MILITARY SPECIFICATION

SINKS, SERVICE, NAVAL SHIPBOARD

This amendment forms a part of Military Specification MIL-S-2143B(SHIPS), 7 June 1967.

Figure 1 - Service sink.

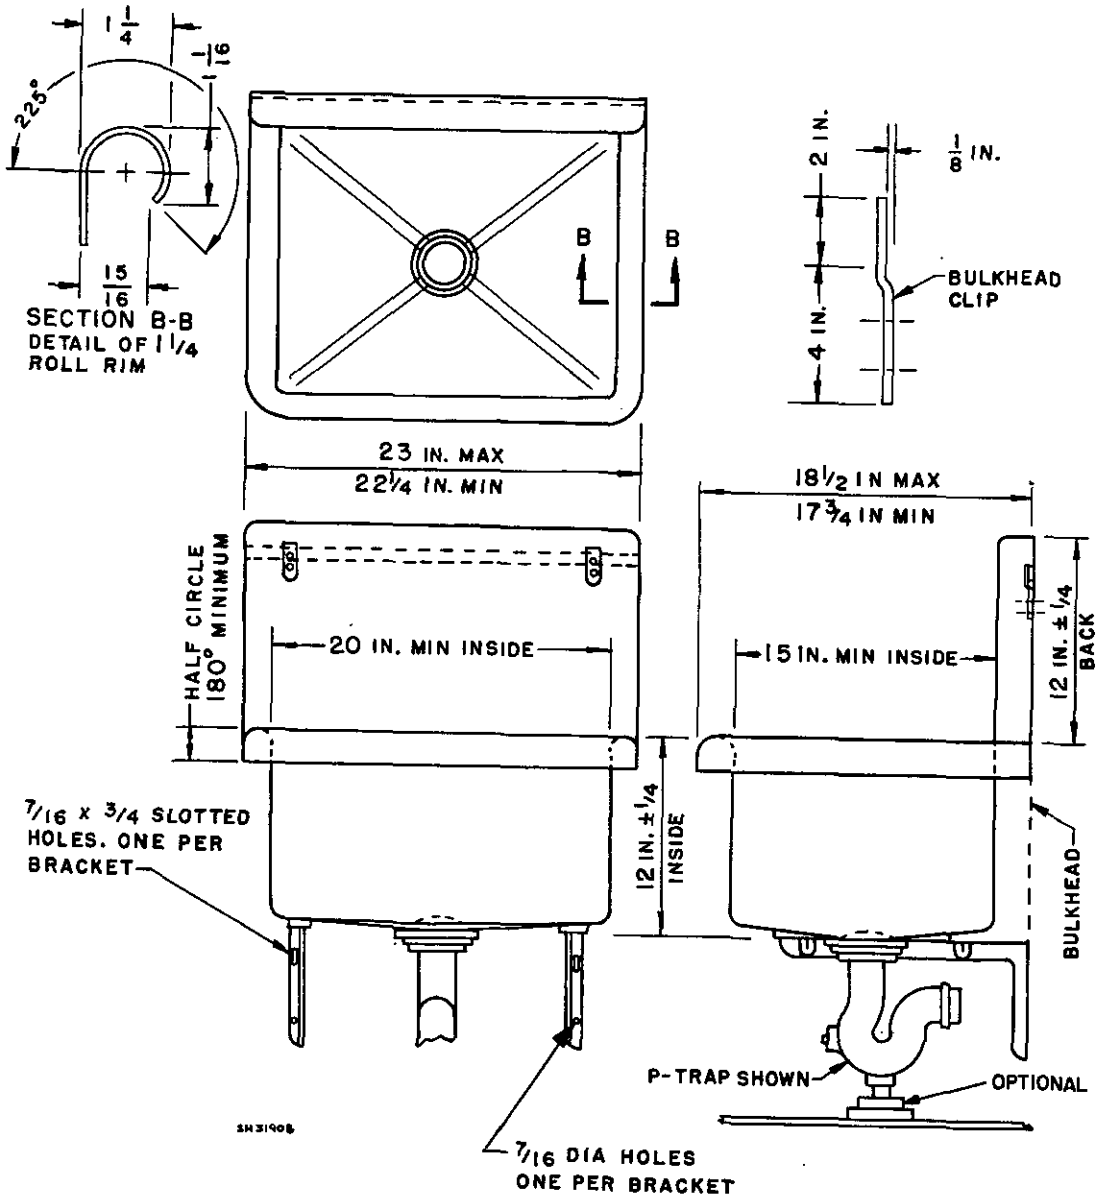
Figure 1: Delete and substitute the attached figure.
